DEVELOPMENT APPLICATION ASSESSMENT REPORT

Application Number:	DA2020/0170
----------------------------	-------------

Responsible Officer:	Catriona Shirley
Land to be developed (Address):	Lot 23 DP 222901, 46 Pringle Avenue BELROSE NSW 2085
Proposed Development:	Demolition works and construction of a dwelling house
Zoning:	Warringah LEP2011 - Land zoned R2 Low Density Residential
Development Permissible:	Yes
Existing Use Rights:	No
Consent Authority:	Northern Beaches Council
Land and Environment Court Action:	No
Owner:	Sharon Stella Ignacio Reynante Ignacio
Applicant:	Metricon Homes Pty Ltd

Figure 1. Front setback variation shown in green.

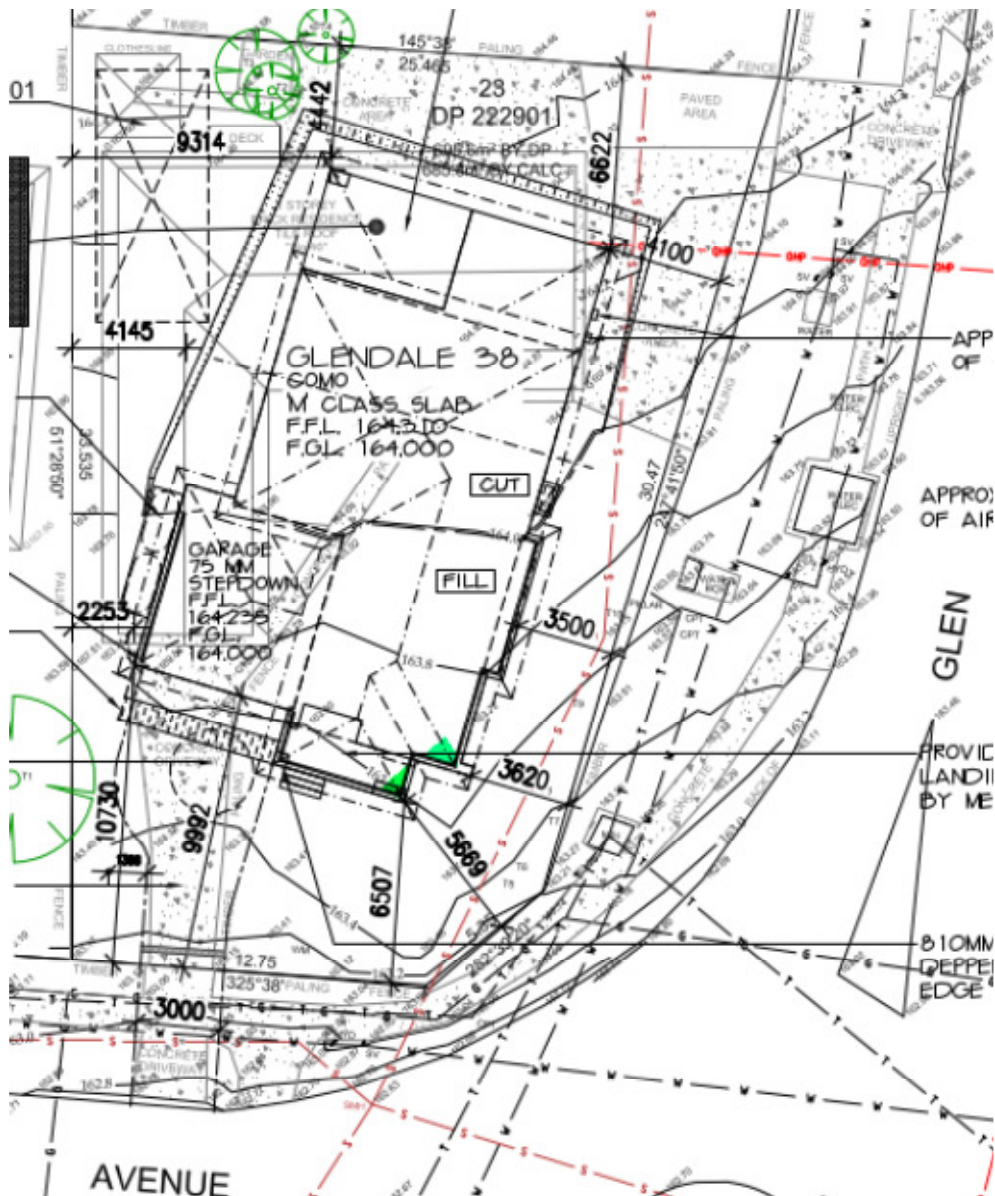
The proposed setback of the new dwelling house is 10.7m - 6.5m to Pringle Avenue, and 5.7m to the splayed front boundary of Pringle Avenue creating a variation of 12.7% to the frontage control.

The non-compliance relates to two small south-west corners of the dwelling, and relates to a front column 5.78m in height and a 1st floor balcony on the level above and a wall of 4.2m.

The predominant footprint of the dwelling on its south and west elevation remains behind the front setback. The dwelling house is well designed and articulated with steps both on the northern and eastern front setback elevations, open balcony areas, and changes in materials that provide sufficient articulation and visual breaks in the building to improve the sense of openness.

Having regard to the above assessment, it is concluded that the proposed development is consistent with the relevant objectives of WLEP 2011 / WDCP and the objectives specified in s1.3 of the Environmental Planning and Assessment Act, 1979. Accordingly, this assessment finds that the proposal is supported, in this particular circumstance.
